Re: Response to Kerry County Council Submission

10 year planning permission for the proposed Open Cycle Gas Turbine (OCGT) power plant fuelled by Hydrotreated Vegetable Oil (HVO) and associated site works at Tarbert Island, Tarbert, Co. Kerry.

Technical Note (Flood Wall)

To SSE	Project name Tarbert Bio-fuel Plant	Project number 60695232	Client SSE
Subject Technical Note (Flood Wall)	Date 21 March 2024	Document ref TN TBP/001	Issued by AECOM
Reason for issue Response to Chief Executive Report for Tarbert by Kerry County Council	Prepared by Various	Checked by Sreeraj Menon	Approved by Peter Neville-Jones
Revision No. 03

Figure 1. IPCC AR6 sea level rise data for location: 52.0°N, 11.0°W and SSP5-8.5 scenario

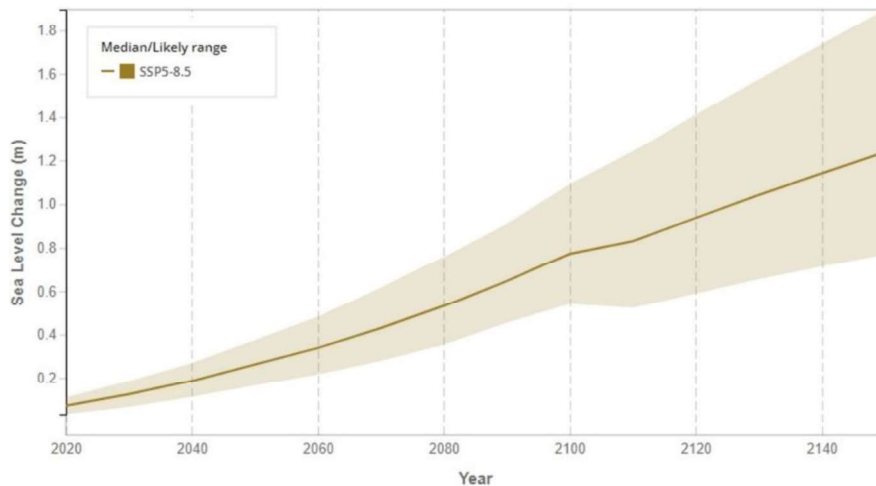
Kerry County Council (KCC) has requested further justification for setting the height of the proposed flood wall at an elevation of +7.54m ODP and has requested that this is raised to +7.90m ODP. The level of +7.54m ODP is 0.04m higher than that proposed in the Updated Coastal Flood Risk Assessment (Mott MacDonald, 2020) which notes that the new defences would be up to 1.5m above existing ground levels and typically only 1m higher. Raising the crest of the flood defences to +7.90m ODP would therefore increase their height to between 1.4m to 1.9m above ground levels.

The above confirms that a highly conservative approach is adopted for the estimation of future sea level rise by using the 95th percentile values. Figure 1 shows the variation in sea levels for a point off the west coast of Ireland (52°N, 11°W) created using the NASA Sea Level Projection Tool³. It is reasonable to assume that a very similar trend in mean sea levels will be found at the Tarbert Island site within the Shannon Estuary.

As shown in Table 5, the refined estimate of sea level rise results in a design crest level for the flood wall and other flood defence structures of +7.51m ODP for a 25-year design life. This is marginally lower than the +7.54m ODP indicated on the design drawings. The reason for this minor discrepancy is the slightly conservative approach previously used to estimate future sea level rise.

If an extended design life of 50 years is required for the Tarbert Island Bio-fuel Plant, then the design crest level should be raised by 0.5m to at least +8.01m ODP.
